UNITED STATES PATENT AND TRADEMARK OFFICE

APPLICATION NO.	FILING DATE	FIRST NAMED INVENTOR	ATTORNEY DOCKET NO.	CONFIRMATION NO.
10/666,595	09/18/2003	Elliott Malcolm Philofsky	ACR-0301	8539

Office Action Summary	Application No. 10/666,595	Applicant(s) PHILOFSKY, ELLIOTT MALCOLM	
	Examiner Eric W Thomas	Art Unit 2831

DETAILED ACTION

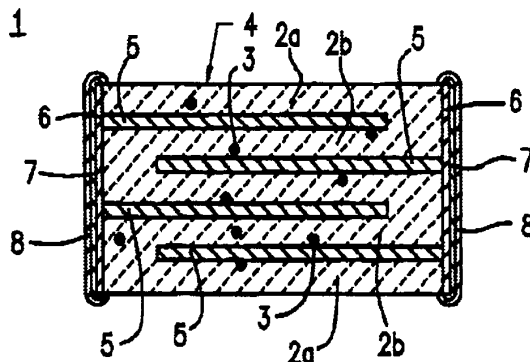
6. The drawings are objected to because one of the reference numbers is not clear (see below)

Is this element 28 or 20?

7. A proposed drawing correction or corrected drawings are required in reply to the Office action to avoid abandonment of the application. The objection to the drawings will not be held in abeyance.

FIGURE 1D

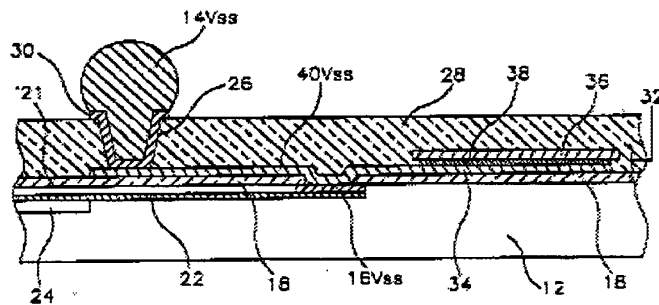
Akram et al. disclose in fig. 1D, 1E, a capacitor for an integrated circuit a first nickel electrode (34) coupled to an electrical lead of the integrated circuit; a dielectric

(38) applied to the first nickel electrode; and a second nickel electrode (36) applied to the dielectric and attached to a second electrical lead of the integrated circuit.

FIGURE 1E

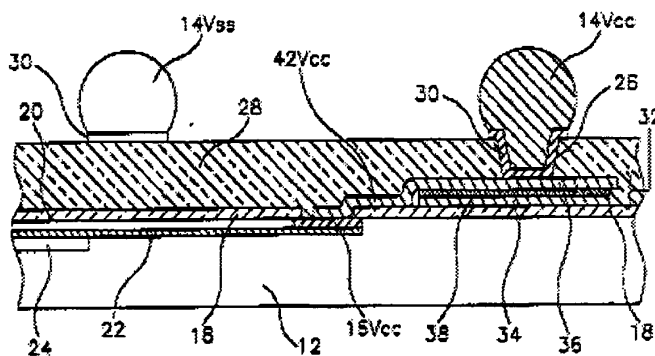
Regarding claim 9, Akram et al. disclose a portion of the second electrode on a passivation layer (18) of the integrated circuit.

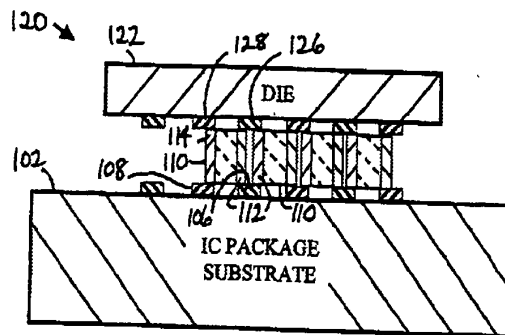
Patel et al. disclose in fig. 4, a capacitor connected to an integrated circuit.

Regarding claim 4, Patel et al. disclose the capacitor (first electrode) is adjacent to a lead on an integrated circuit (pad – 106, 108). Patel et al. disclose the claimed invention except for the lead on the integrated circuit is formed from an aluminum material. Aluminum is a well-known material used as lead (pads) in the IC/capacitor art. It would have been obvious to a person of ordinary skill in the art at the time the invention was made to form the leads of Patel et al. with an aluminum material, since it has been held to be within the general skill of a worker in the art to select a known material on the basis of its suitability for the intended use as a matter of obvious design choice. In re Leshin, 125 USPQ 416.

Regarding claim 7, Patel et al. disclose in fig. 4, a capacitor for an integrated circuit wherein a first electrode is connected to an electrical lead of the integrated circuit (pad – 108), a second electrode is connected to a second electrical lead of the integrated circuit (pad – 106).

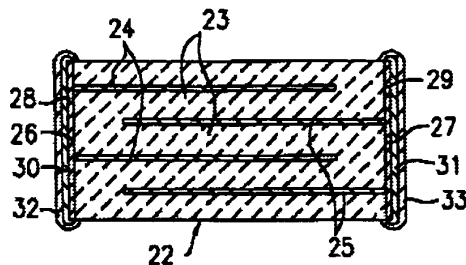
Konaka et al. teach in fig. 1, a capacitor comprising a first nickel (col. 7 lines 13-18) electrode (25); a BCTZ (see abstract) dielectric covering a side of the first nickel electrode; and a second nickel (col. 7 lines 13-18) electrode (24) sandwiching the BCTZ.

Regarding claim 5, Konaka et al. teach that the capacitor has nickel (col. 7 lines 53-56) leads (30, 31). Patel et al. disclose the capacitor is connected to a second lead on the integrated circuit. Patel et al. do not disclose the second lead is formed from an aluminum material. Aluminum is a well-known material used as lead (pads) in the IC/capacitor art. It would have been obvious to a person of ordinary skill in the art at the time the invention was made to form the leads of Patel et al. with an aluminum material, since it has been held to be within the general skill of a worker in the art to select a known material on the basis of its suitability for the intended use as a matter of obvious design choice. In re Leshin, 125 USPQ 416.
